UNITED STATES  
NUCLEAR REGULATORY COMMISSION  
WASHINGTON, D. C. 20555

ENCLOSURE 2

SAFETY EVALUATION OF THE REQUEST TO OPERATE  
THE SHOREHAM NUCLEAR POWER STATION AT 25% POWER  
ACCIDENT EVALUATION

Figure 11 CRAC2 calculated dose-versus-distance probability distributions for whole body dose of 5 rem -- early release scenario

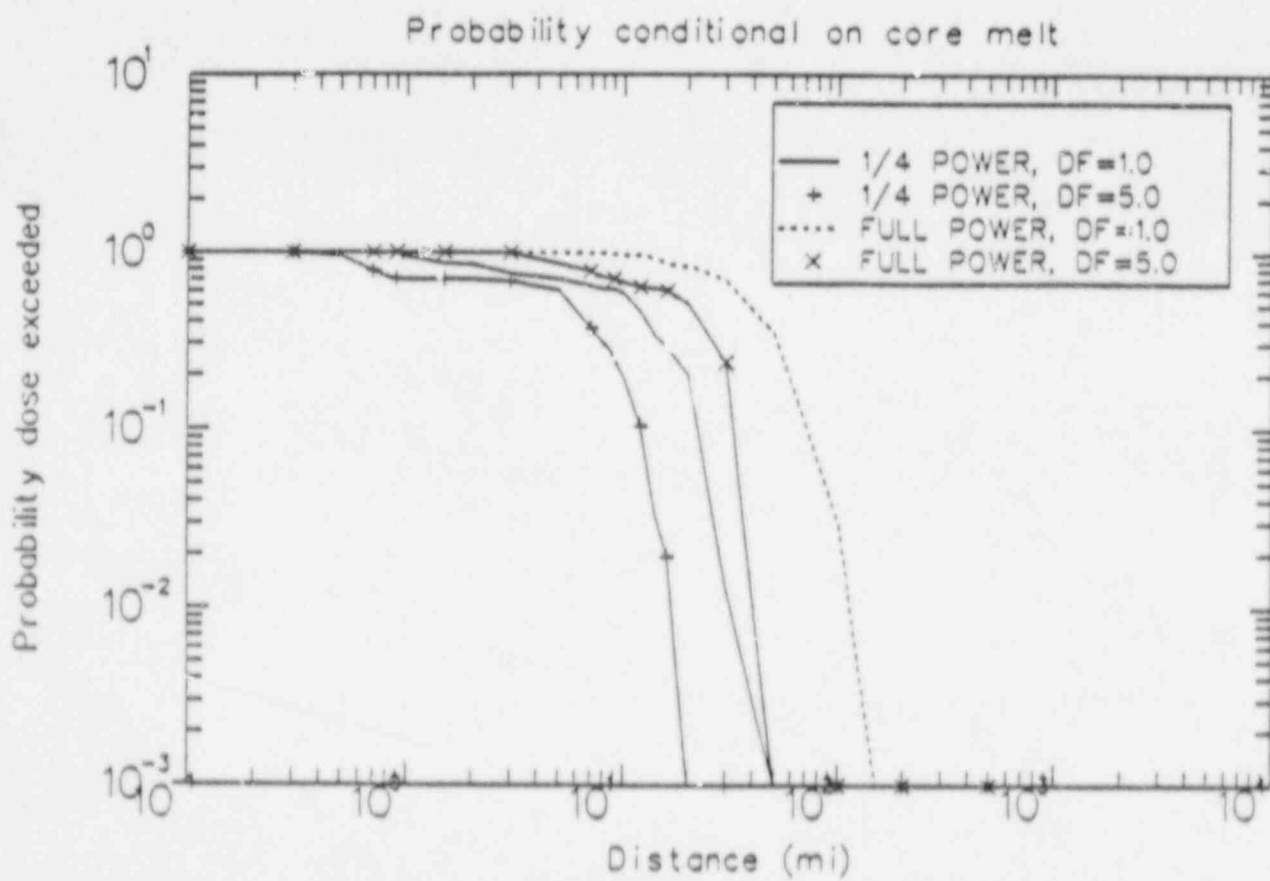
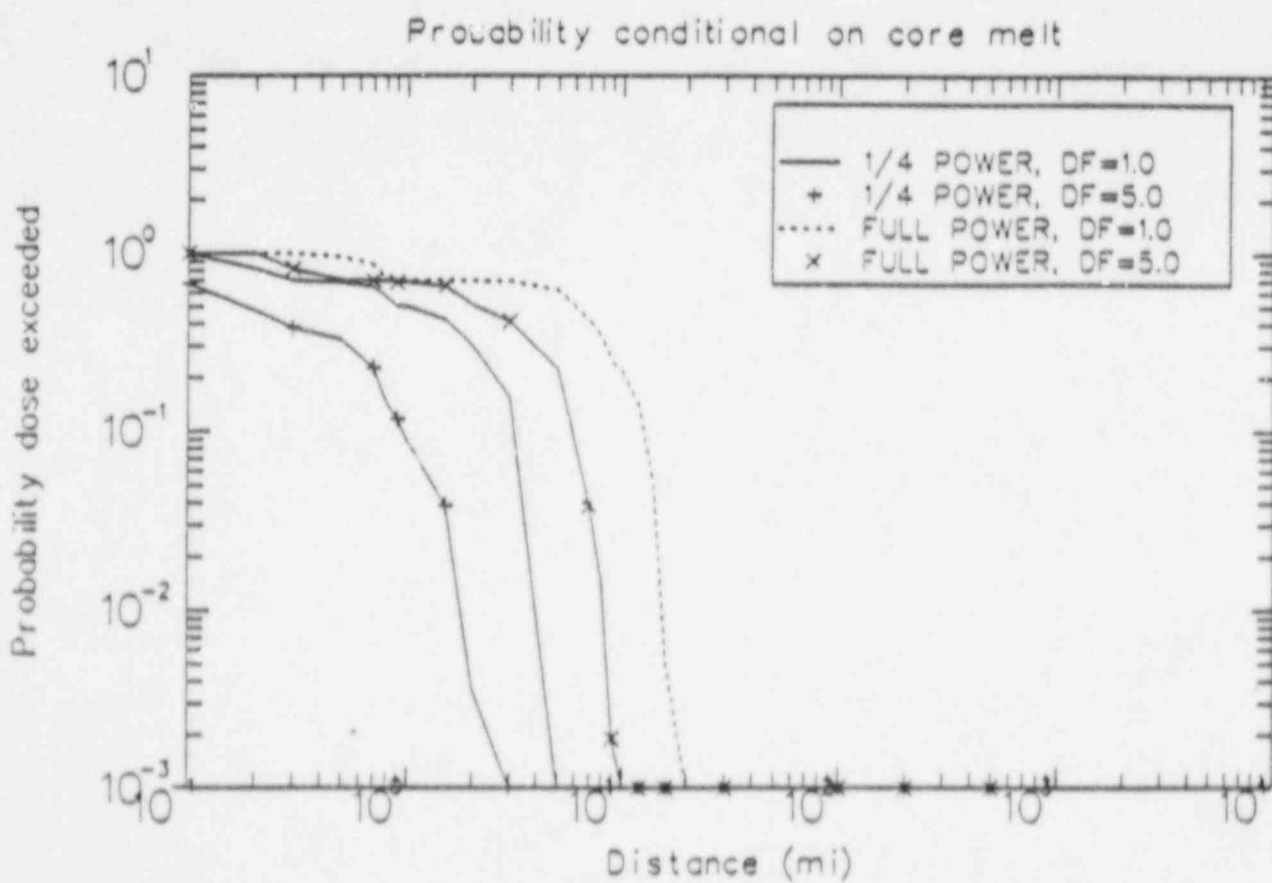
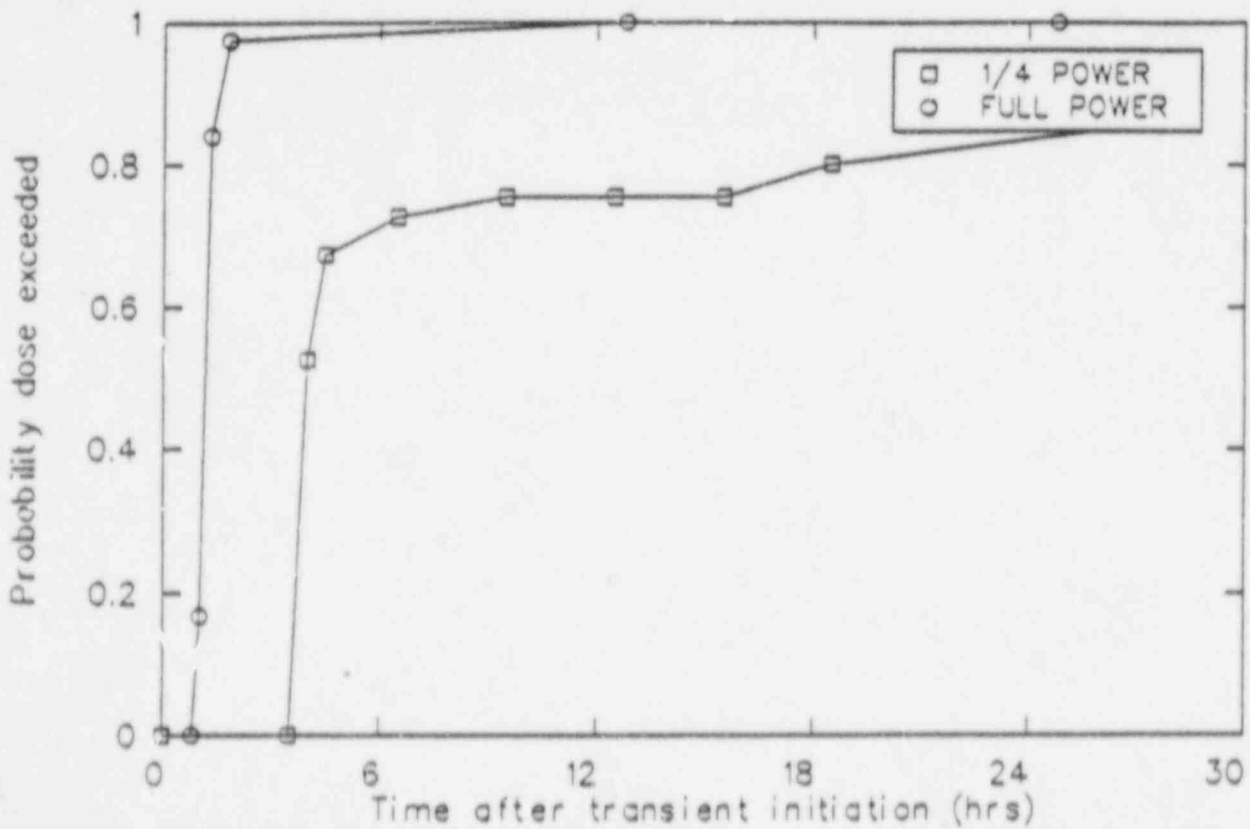
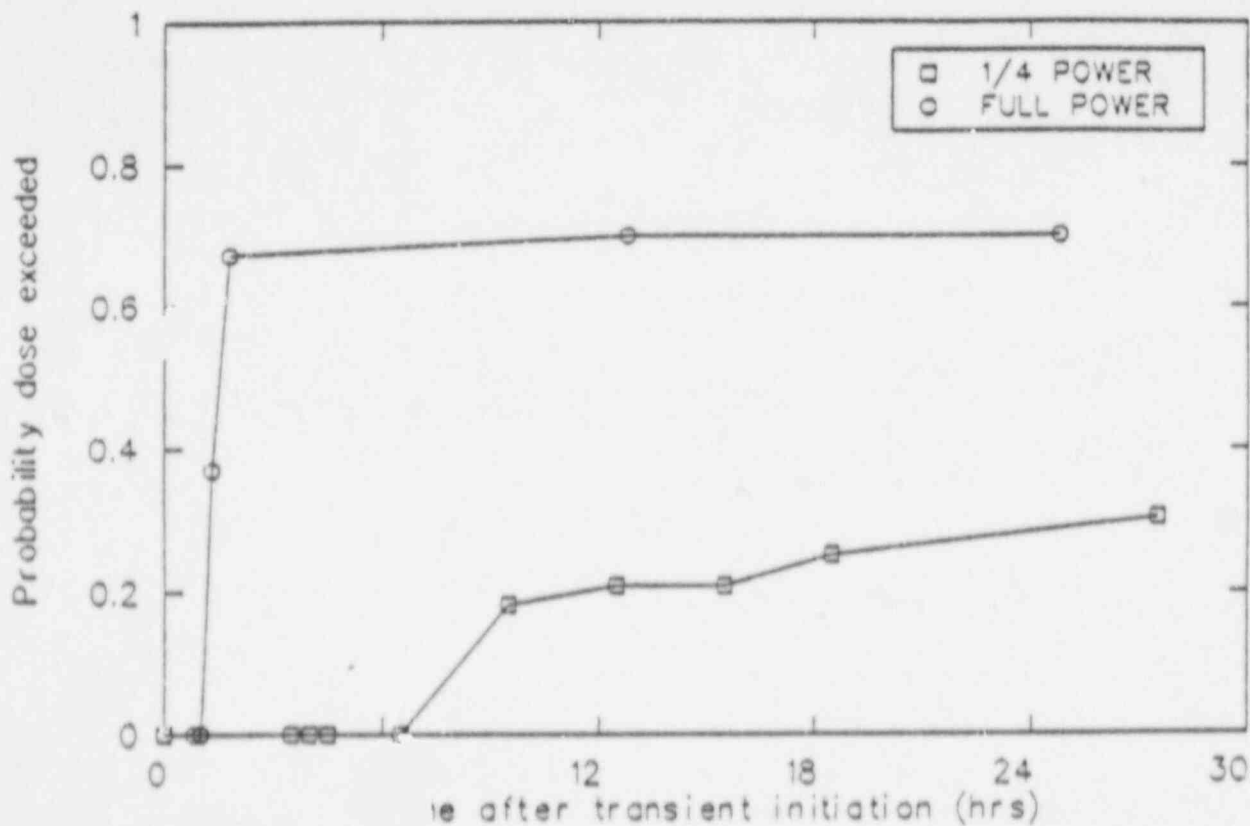
Based on the staff-developed source term, offsite consequence calculations were performed for operation at 25 percent and 100 percent power using the CRAC2 code. Table 17 lists the release fractions used in these calculations. Figures 11 and 12 show the five and 200 rem dose-versus-distance results for the various cases. As expected, the staff's dose-versus-distance probabilities were higher than those reported by LILCO. Also, the same general trends described in the previous section for slowly evolving transients can be observed here, specifically, that reducing the reactor power from 100 percent to 25 percent represents a significant reduction in the probability of exceeding a given dose, or conversely, a significant reduction in the distance over which a given dose would be exceeded.

To provide some perspective as to the additional time for protective actions afforded by operation at 25 percent power, a set of dose-versus-time release conditional probability figures were generated following the procedure described in Section 4.2.2. Figures 13 and 14 show the probability of five and 200 rem whole-body doses being exceeded at two miles versus time for 25 percent and 100 percent power. The probability of exceeding the five rem dose two miles from the reactor approaches the 24-hour value quite rapidly for both 25 percent and 100 percent power, and the difference in the time required to reach a given probability of exceedance is comparable to the differences in the time to release for the 25 percent and 100 percent power cases. For the 200 rem doses, the results for full power indicate that following the time of release (0.8 hours) the probability of exceedance at two miles rapidly approaches its 24-hour value. For 25 percent power, CRAC2 indicates a much lower dose accumulation rate; specifically, 200 rem doses are not exceeded until about three hours after the time of release (3.5 hours) or six hours after transient initiation. Since there is a significantly shorter time to release for 100 percent power and a high probability that a 200 rem whole-body dose will be exceeded very shortly after the release, less dose savings could be realized for 100 percent power operation.
